MEMORANDUM

**Subject: Review of Contaminant Conditions
CSXT Bramlette Road Former Manufactured Gas Plant (MGP)
Greenville, South Carolina
Project No.: 019-12**

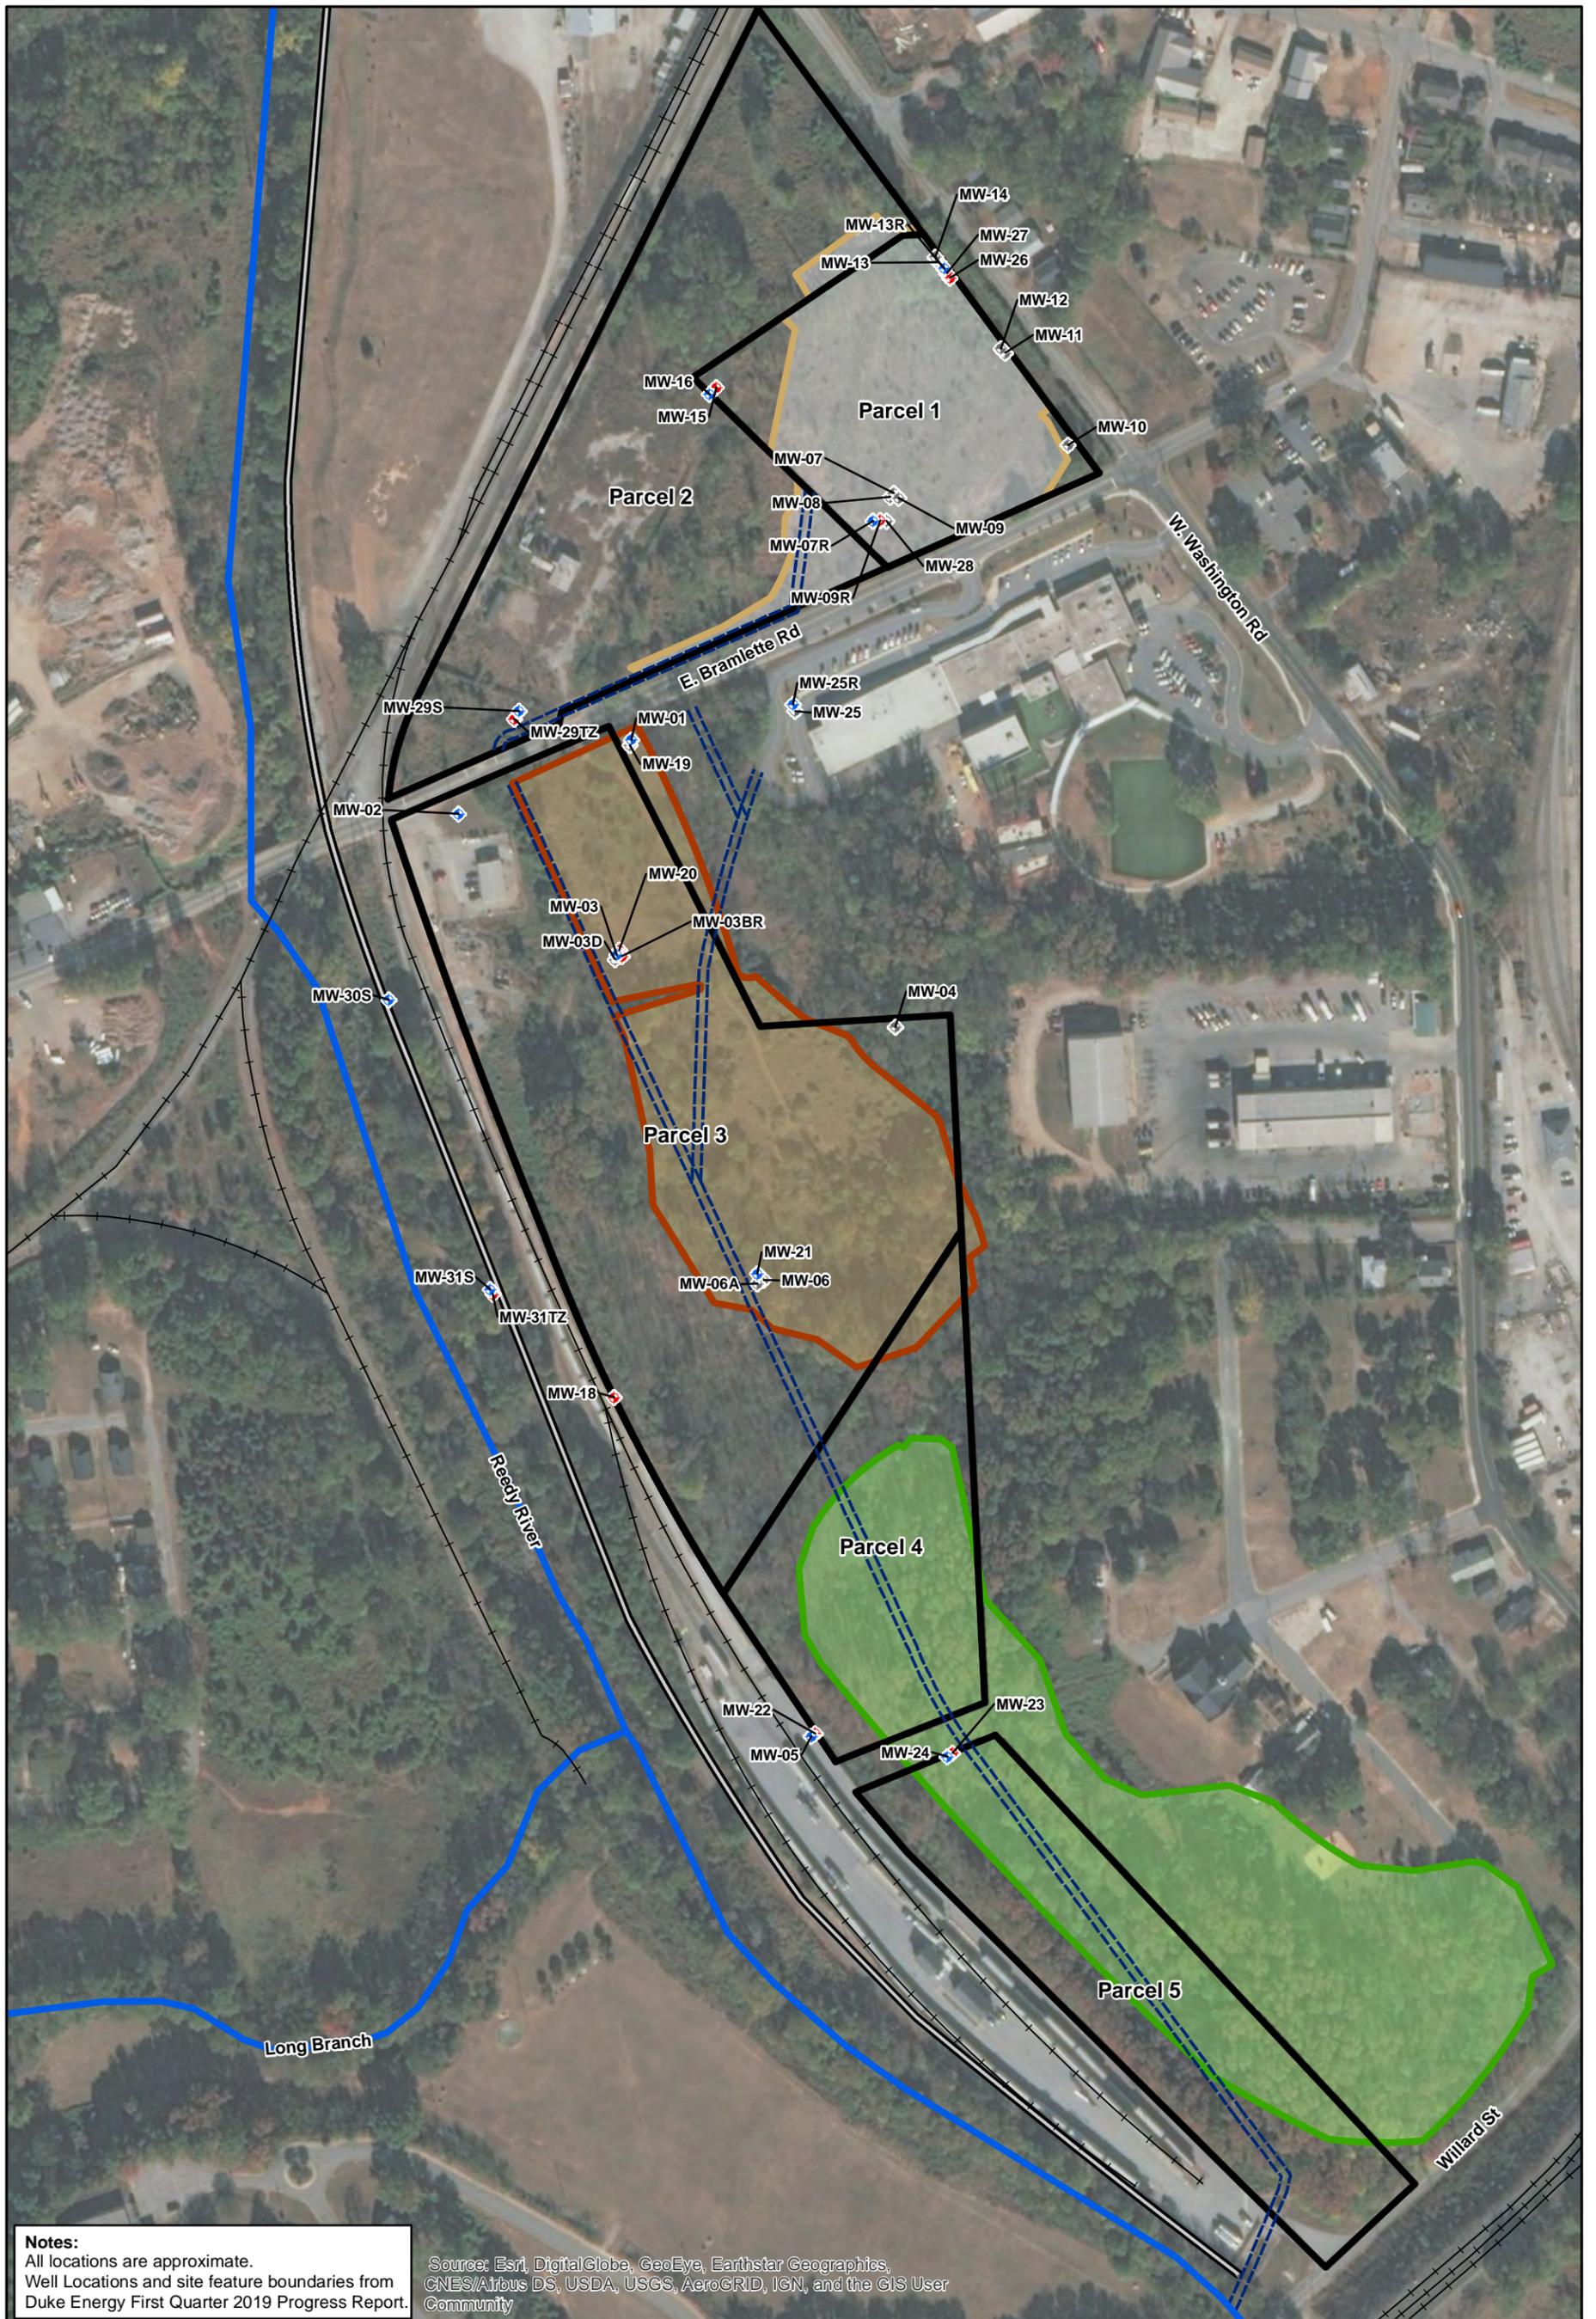
2. Remove contaminated sediment along the course of the current drainage ditch across Parcels 3, 4 and 5 to the confluence of the drainage ditch with the Reedy River (**Figure 1**). Excavation could involve the removal of as much as a 50-foot wide swath to a depth of approximately 3 feet centered on the drainage ditch.

Neither the maximum depth nor the down-gradient extent of benzene and naphthalene (as indicator compounds for VOC and SVOC contamination) contamination in groundwater have been delineated (**Figures 4 through 7**). As mentioned above, benzene and naphthalene were detected at concentrations of 1,920 ug/L and 4,060 ug/L, respectively, in a groundwater sample taken from MW-29TZ. MW-29TZ is located approximately 500 feet down-gradient of the former MGP. No monitoring wells have been installed beyond MW-29TZ north of East Bramlette Road in the down-gradient direction (**Figure 1**).

The outflow of the culvert beneath East Bramlette Road is actually on property to the east of Parcel 3 (**Figure 1**). From this culvert, the wastewater flowed in a ditch running towards the south-southeast to join another ditch, which then ran south-southwestwards to enter Parcel 3. The portion of this ditch beneath Parcel 3 is now covered by the Vaughn Landfill. **Figure 1** shows that this ditch originally flowed into another drainage channel running the full length of Parcels 3, 4, and 5. It is uncertain whether this drainage channel entered Parcel 3 from a second culvert underneath East Bramlette Road, approximately mid-way along the northern boundary (interpretation 2 described above) or only exists south of East Bramlette Road (interpretation 3, suggested by the latest SynTerra (2019) report). In any case, this channel formerly flowed into ponds near the southern end of the Vaughn Landfill.

Date: 10/11/2019	Project #: 019-12	Figure 2
------------------	-------------------	-----------------

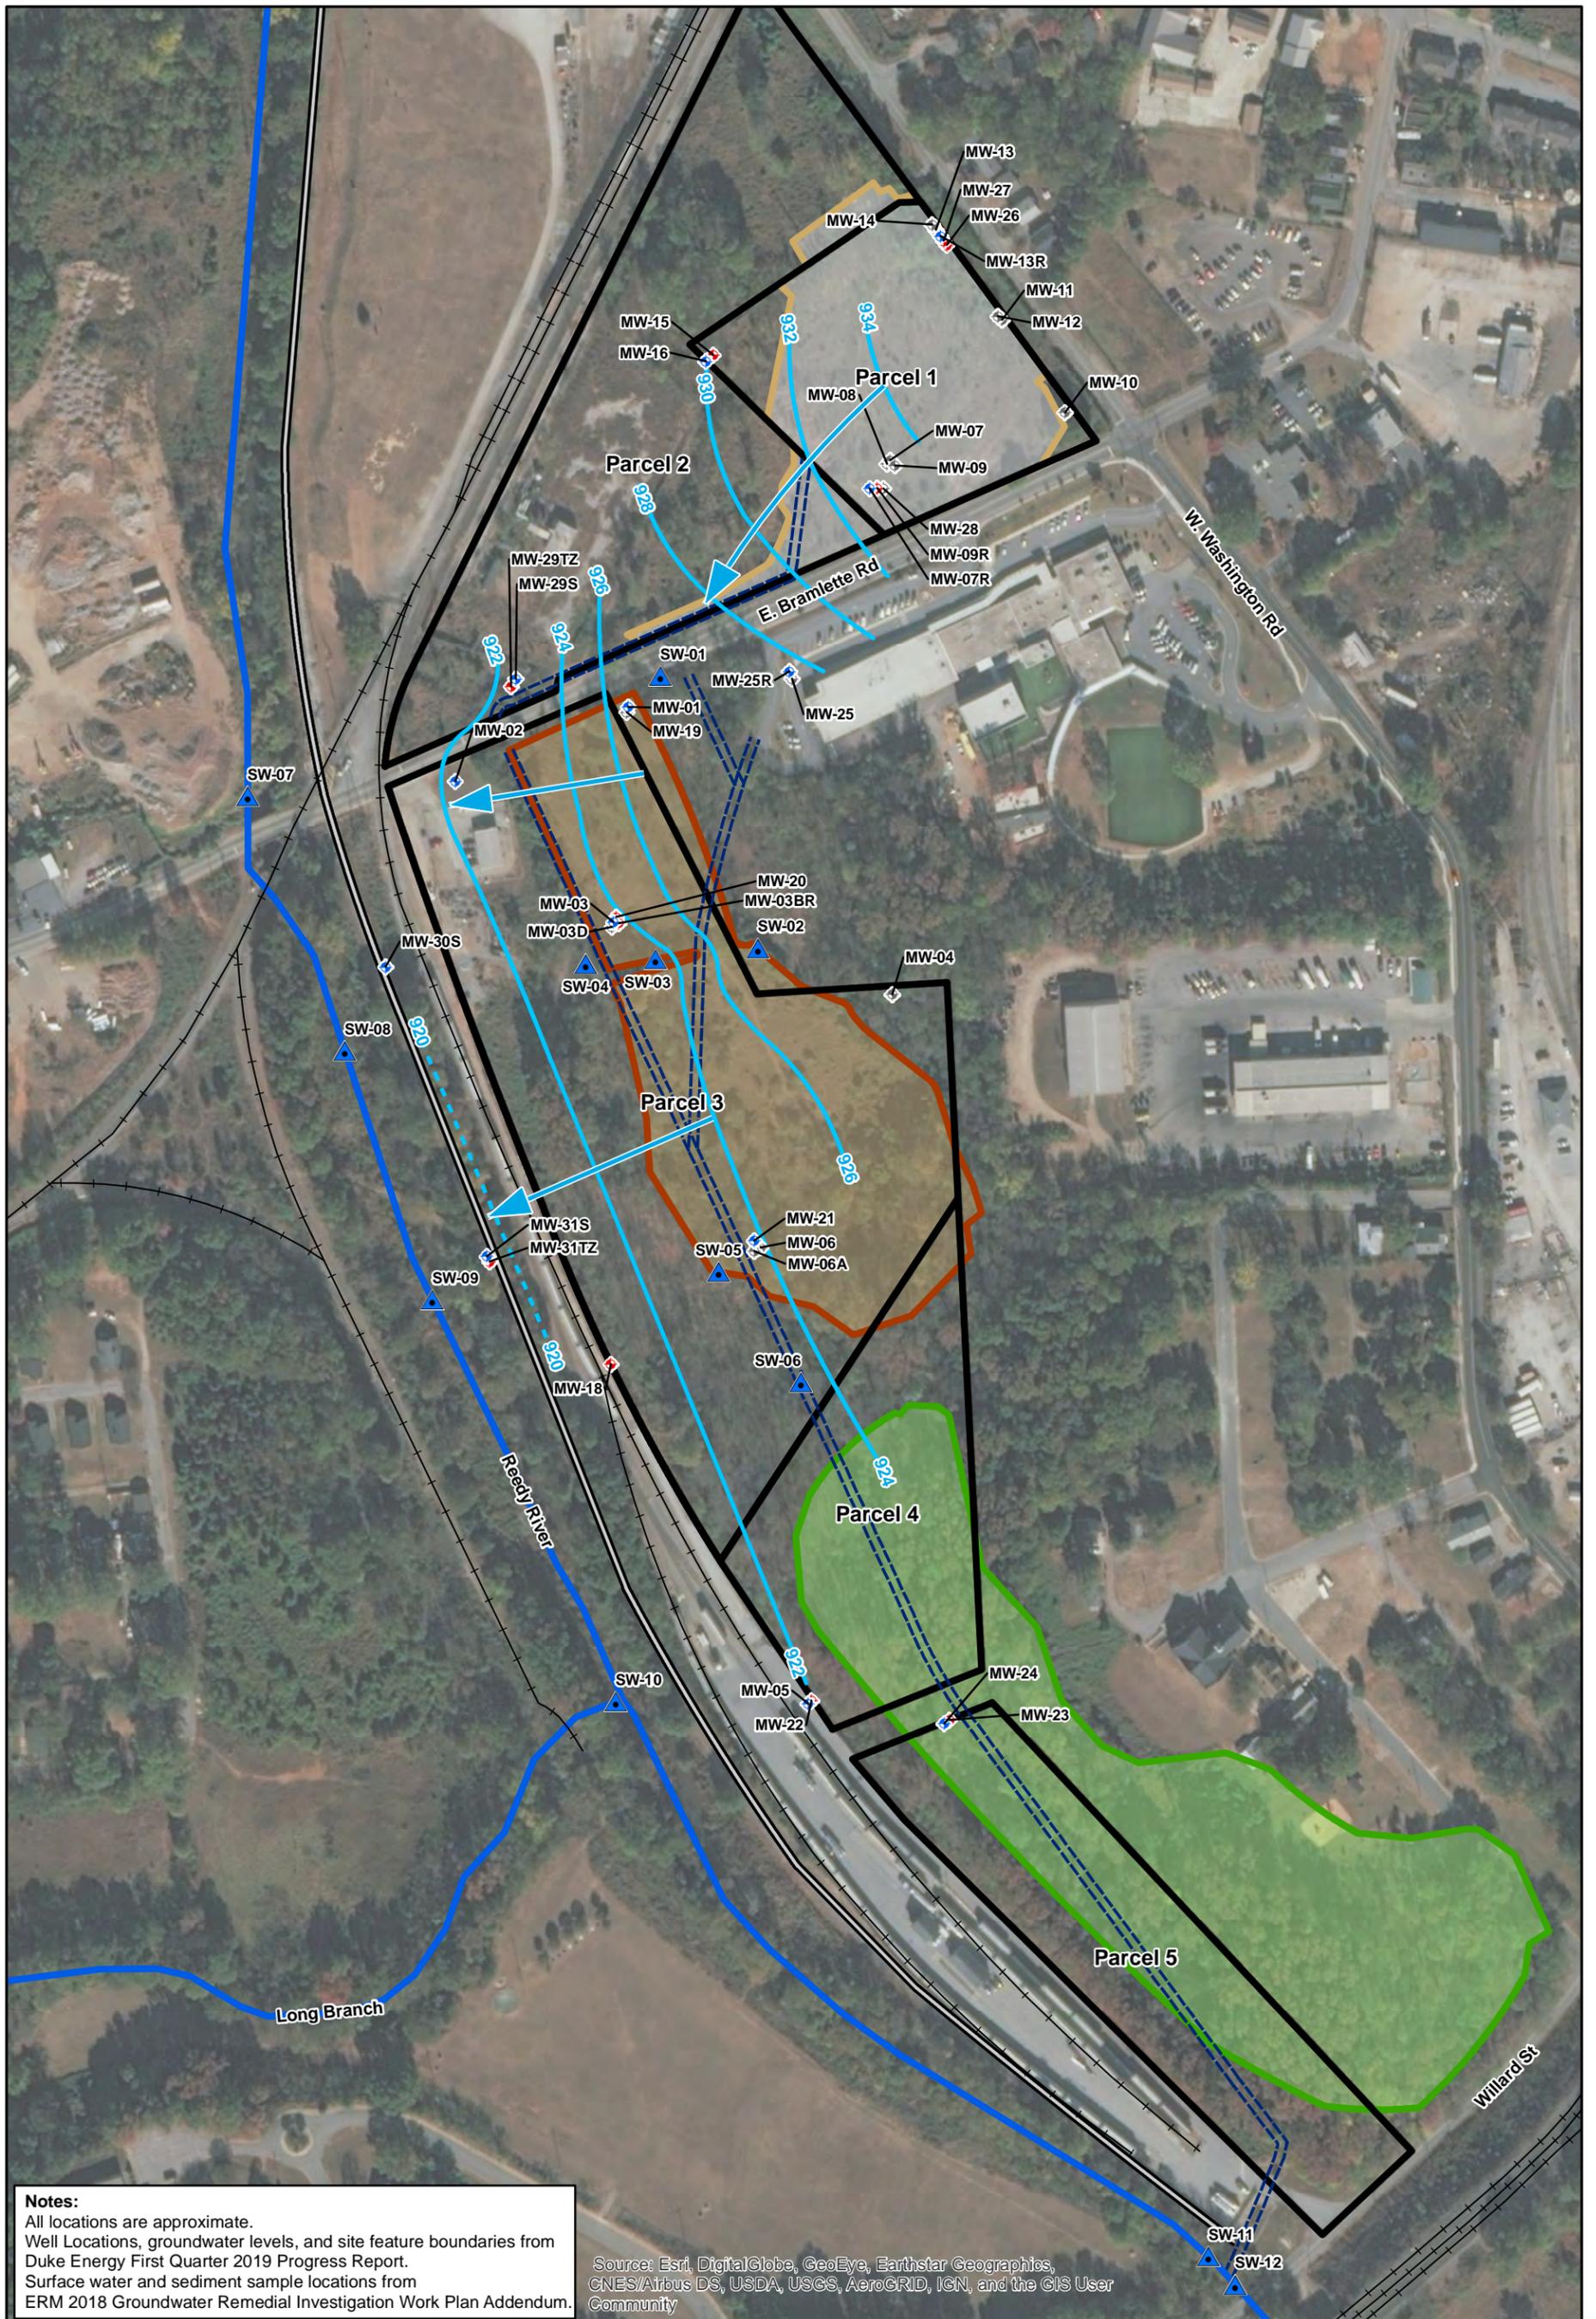
In December 2018, six sediment samples were collected along the Reedy River (i.e., SW-07-SED to SW-12-SED) (**Figure 2**). SVOCs were only detected in sediment sample SW-12-SED collected at the southern boundary of Parcel 5 near Willard Street. The SW-12-SED location is downstream of the point where the current drainage channel discharges into the Reedy River. SVOCs were not detected in any of the other Reedy River sediment samples, all of which are upstream of the drainage channel confluence.

In August 2019, samples of suspended sediment collected from the drainage channel just before its discharge to the Reedy River (**Figure 2**) were found to contain total carcinogenic PAH concentrations of 10,176 ug/kg, 28,200 ug/kg, and 20,270 ug/kg.

Sediment samples WT-1 and WT-2 were collected in April 2019 at locations approximately 60 feet and 170 feet from the confluence with the Reedy River, as indicated in **Figure 2**. Each sample consisted of a composite of 4 scoops of channel-bottom sediments collected from within a 10-foot radius at each location. The samples were analysed for PAHs.

Samples 1D, 2D and 3D were collected in August 2019 at locations approximately 48 feet, 78 feet, and 178 feet from the confluence with the Reedy River, as indicated in **Figure 2**. Unlike samples WT-1 and WT-2, which were channel-bottom sediments, samples 1D, 2D and 3D represented suspended sediment from the water flowing in the channel. A sampling device was fabricated specifically for this purpose. It comprised a metal collecting pan with a slotted cover (see **Photos 21 and 22 in Attachment A**). When placed in the drainage channel (**Photo 20 in Attachment A**), water flows into the device through the slots, and entrained sediment settles out into the pan. At each sample location, the device was positioned in the drainage channel within a shallow pool characterised by low flow velocity. The device was left in the channel for between 4 and 8 days; that is, as long as necessary to collect sufficient sediment for analysis. The accumulated sediment (**Photo 23 in Attachment A**) was then dispatched for analysis of PAHs.

This conclusion is corroborated by analytical results from samples collected from the southern end of the drainage channel on Parcel 5 near Willard Street (**Figure 2**). Grab samples WT1 and WT2 were collected from channel-bottom sediments in April 2019. Total carcinogenic PAH concentrations of 6,608 ug/kg and 17,551 ug/kg were detected in WT1 and WT2, respectively. Samples of suspended sediment were collected from the water column 48 feet (1D), 78 feet (2D), and 178 feet (3D) upstream of the drainage channel's exit point into the Reedy River. Total carcinogenic PAH concentrations of 10,176 ug/kg, 28,200 ug/kg, and 20,270 ug/kg were detected in 1D, 2D, and 3D, respectively. These concentrations greatly exceed the risk-based target cleanup level of 319 ug/kg that was established for remediation of the former MGP in 2001-2002. During sampling, care was taken to ensure that the samples represented suspended material from natural flow in the channel, and not channel-bottom sediment. Therefore, the

Also, in March 2019, six sediment samples were collected from around the Vaughn Landfill in Parcel 3 (i.e., SW-01-SED to SW-06-SED; see **Figure 2**) and analyzed for VOCs and SVOCs. As shown in the table below, carcinogenic PAHs were detected in each of the samples. Total carcinogenic PAH concentrations ranged from 337.3 ug/kg to 9,823 ug/kg, which exceed the site risk-based target cleanup level of 319 ug/kg.
